Subject: Worn Shift Fork and Sliding Clutch Wear on Automated Transmissions

Document Number: TAIB-0818

Worn Yoke

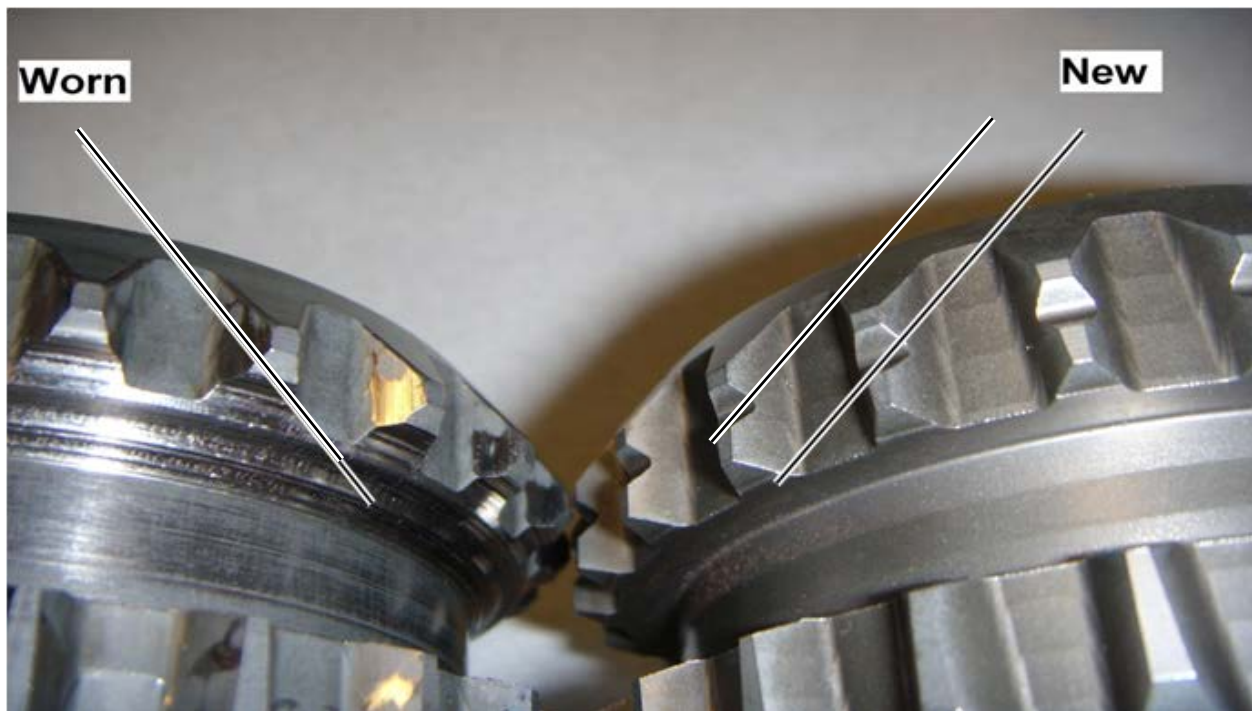
Wear of direct/overdrive shift yoke and sliding clutch on automated transmission models.

The yoke and clutch may be worn on both sides; primary wear will be on the direct side only. The issue is addressed in software version 890 and higher.

Note: This may be inspected thru the 8 bolt PTO opening. Notice the sliding clutch has worn all the way back to the original center groove.

Drain lube, remove 8 bolt PTO cover/ inertia brake and inspect for wear on the front sliding clutch per picture attached. Replace worn components and update to the latest software version.
